FccID: H9PDM4046

Data Phone DS Module

Correspondence # 18840

Date Emailed: 4/11/01

DM4046
RF Side
Cover Removed
NP4046 Configuraton

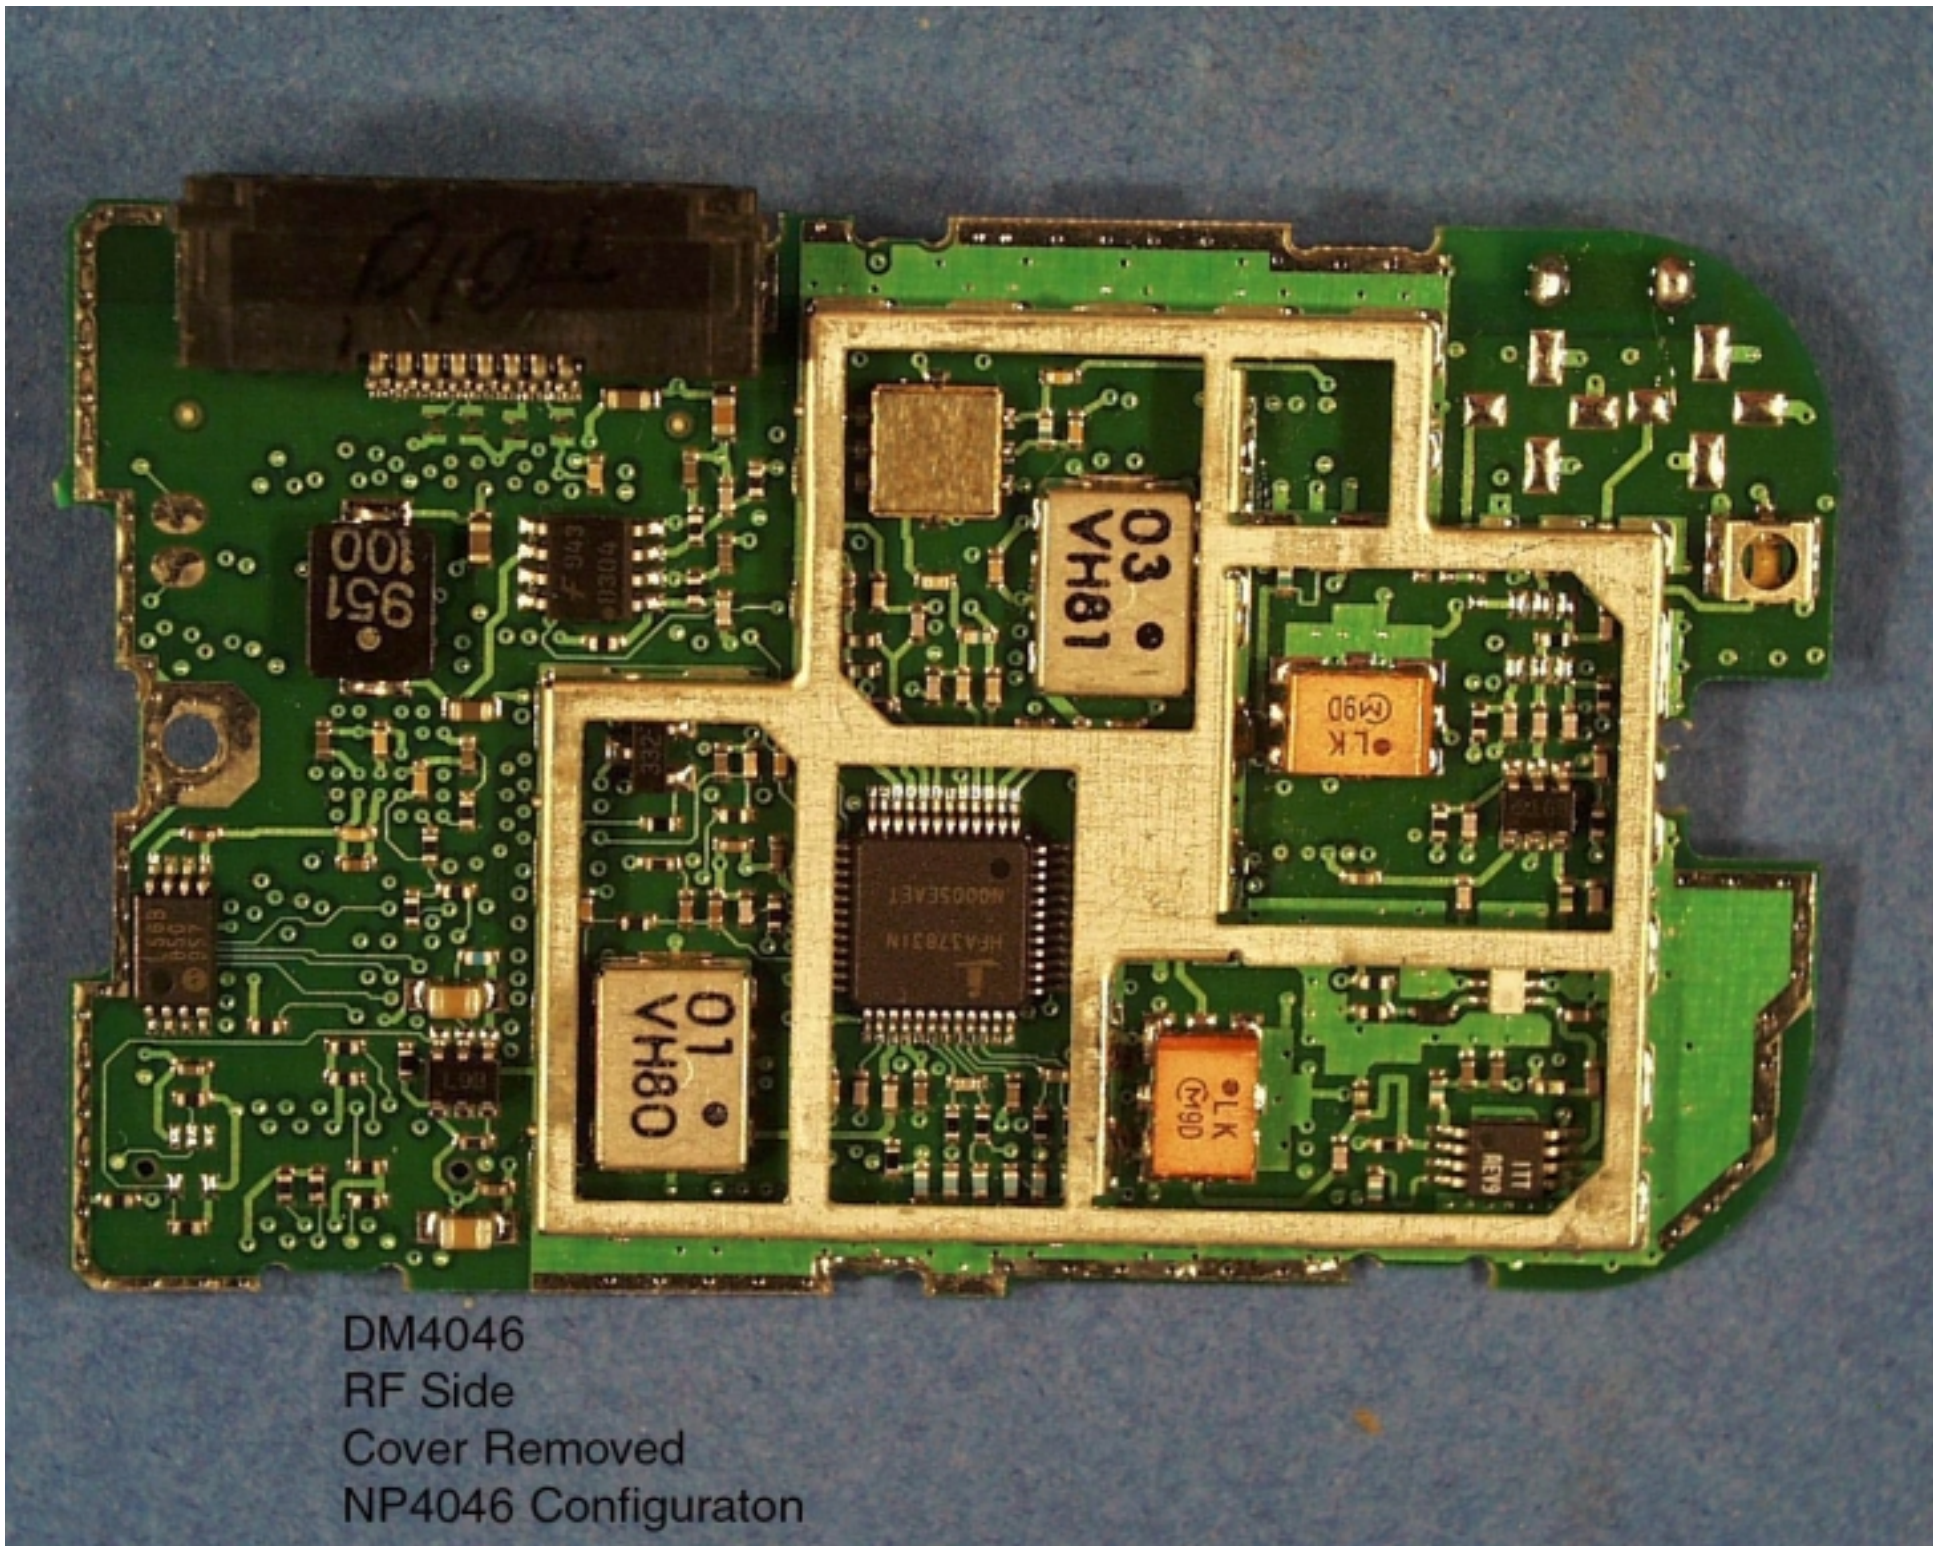
What is the FCC identifier for the LA4021 WLAN card? Confirm that they are the same exact transceiver.

The FCC ID is H9PLA4121. They are the same transceiver.

1. The transmitters are the same.
2. The receivers are the same.

The only difference between the devices are the outline of the PCB and parts of the digital control sections. Although the outline of the PCB is different the layer stackup and thicknesses are the same. I have included a picture of each transceiver so that you may compare them. The transceivers are within the shield frames.
